Document 00 20 00 - Addendum No. 2

SUBJECT: ADDENDUM NO. 2 TO THE BIDDING DOCUMENTS FOR

SE888 Knobview Hall – Replace Air Handling Units
Indiana University Southeast
IU 20250614

SHEET NO.
MD101

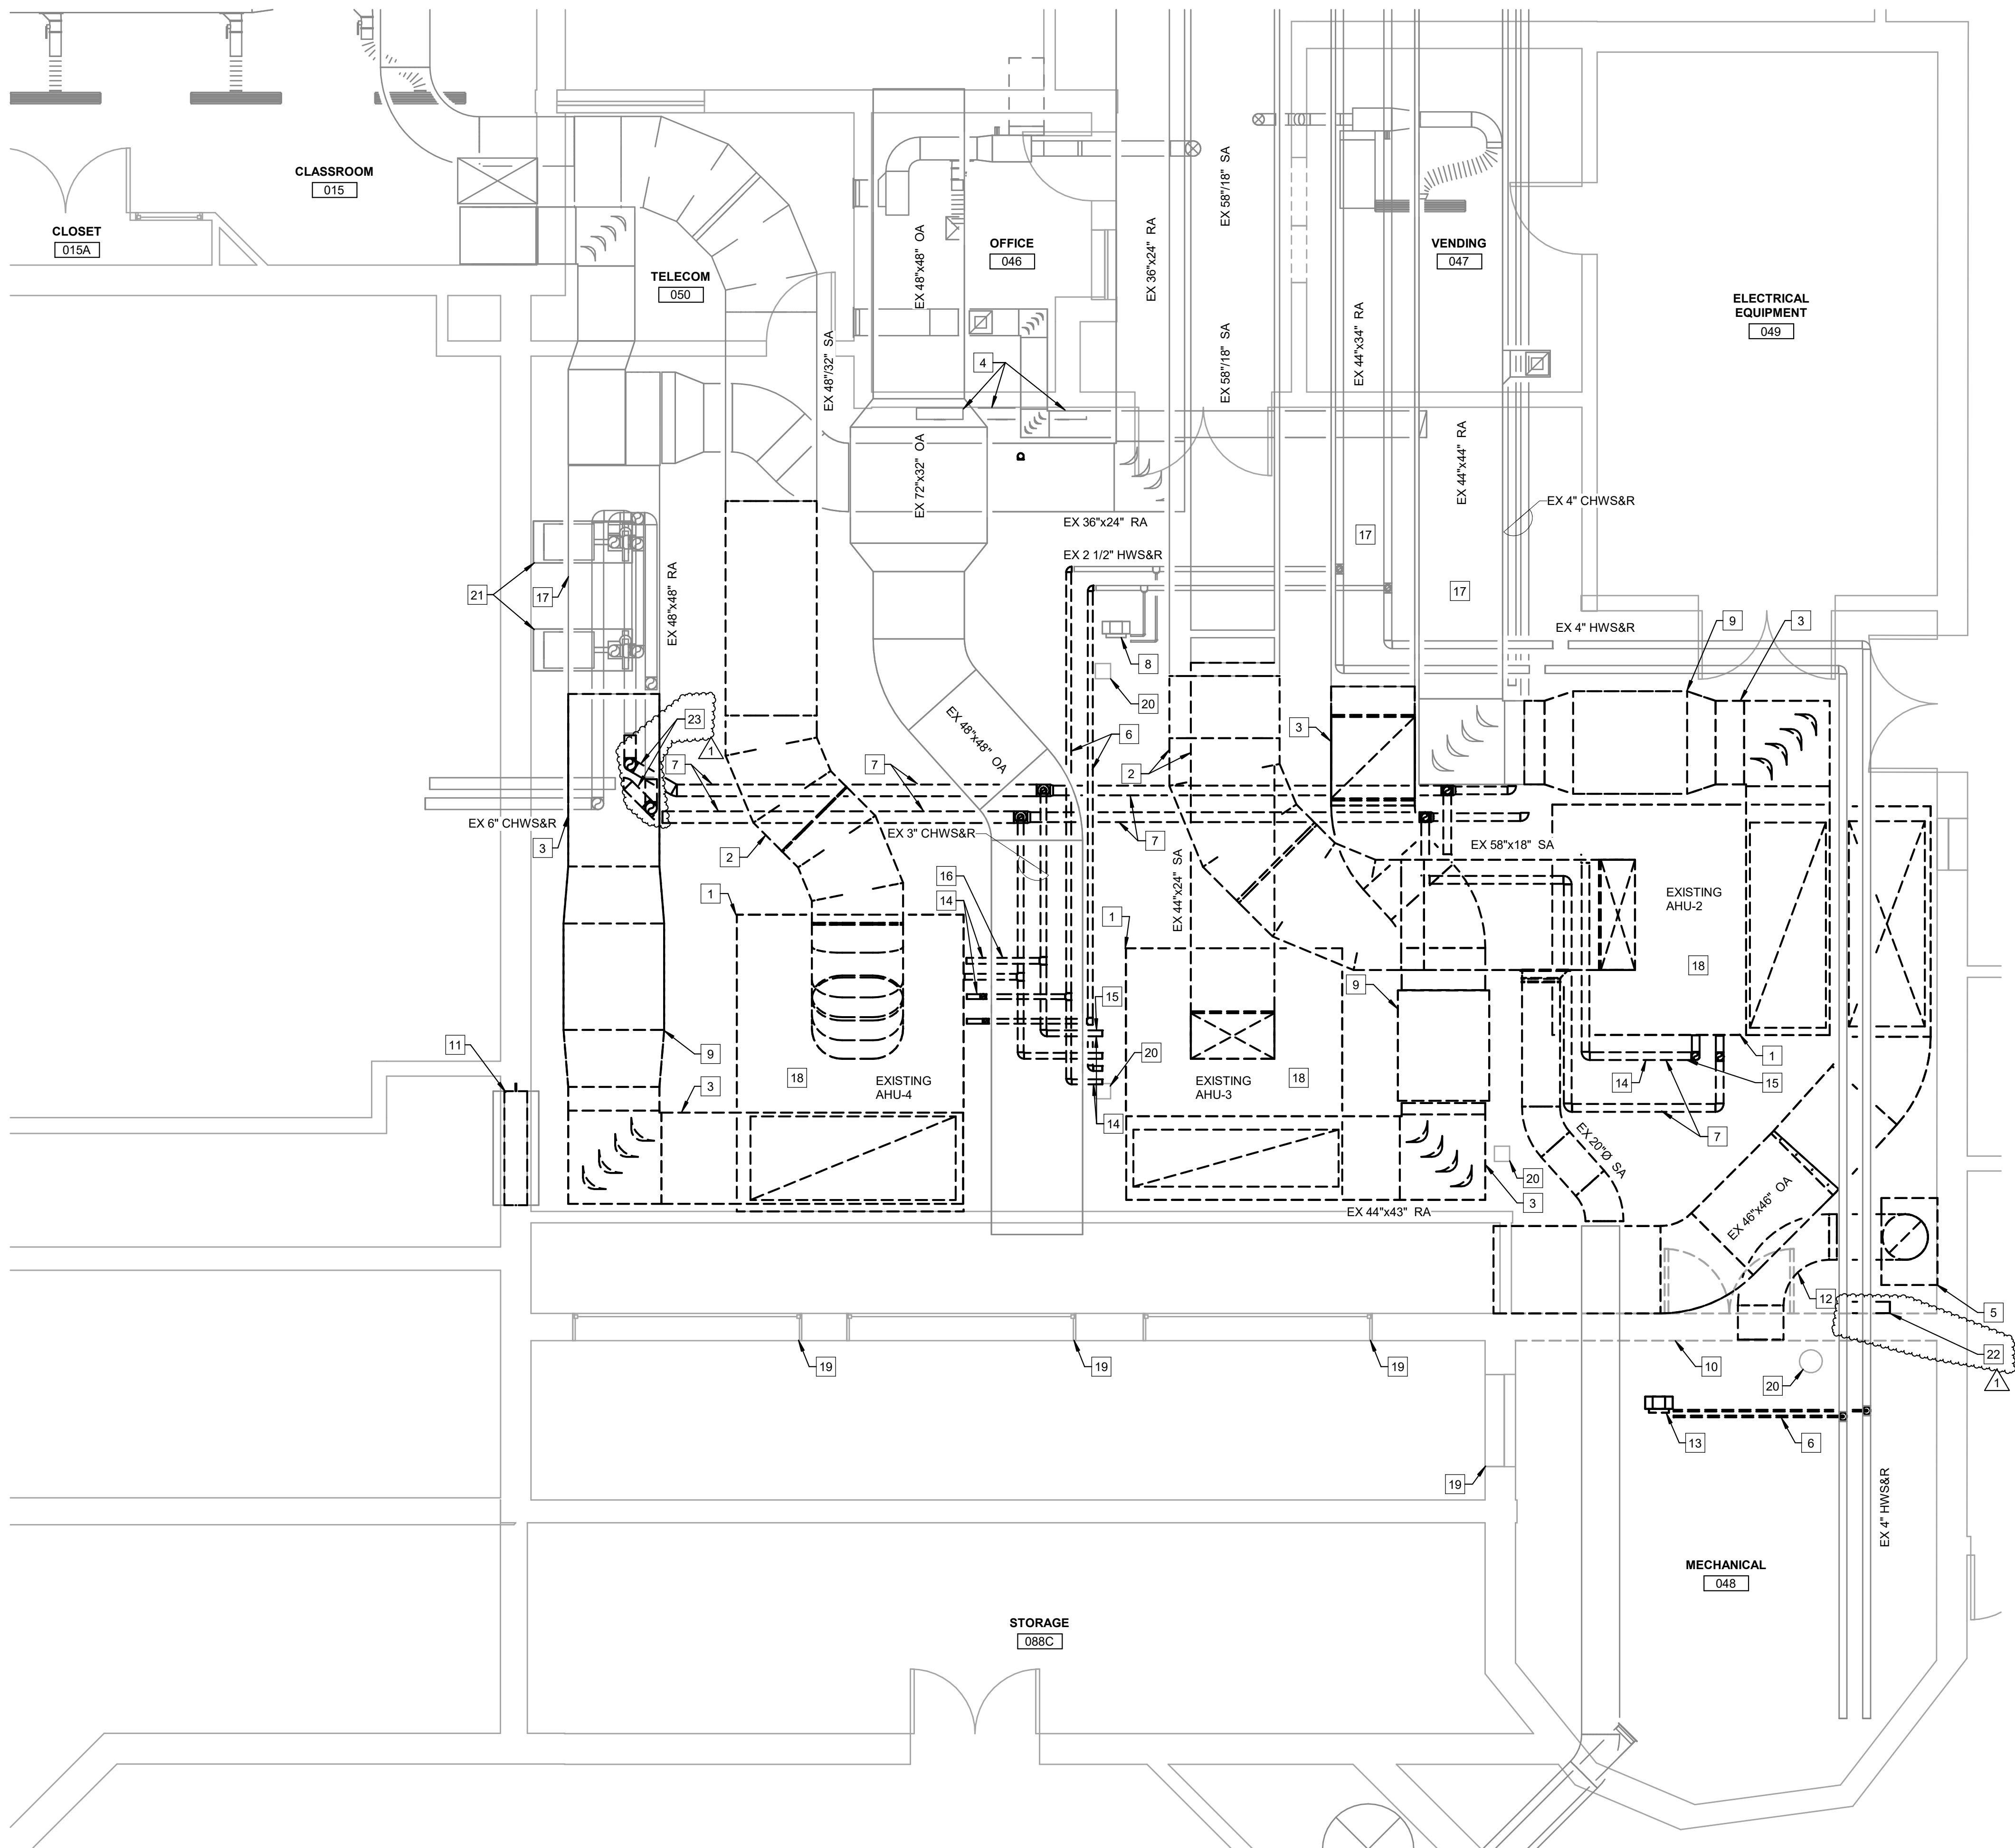
1. Sheet MD101 – GROUND FLOOR MECHANICAL DEMOLITION PLAN:
 - a. Added Keyed Note 22 as indicated on the attached.
 - b. Added Keyed Note 23 as indicated on the attached.

- REMOVE EXISTING TEMPERATURE CONTROL PANEL. EXISTING CONTROLLER SHALL BE RELOCATED TO A DIFFERENT TEMPERATURE CONTROL PANEL LOCATED IN ROOM BY T.C.C..
- REMOVE EXISTING CHECK VALVE AND EXISTING SENSORS AS REQUIRED FOR NEW WORK. EXISTING CHECK VALVE AND EXISTING SENSORS SHALL BE REINSTALLED AFTER COMPLETION OF NEW WORK.
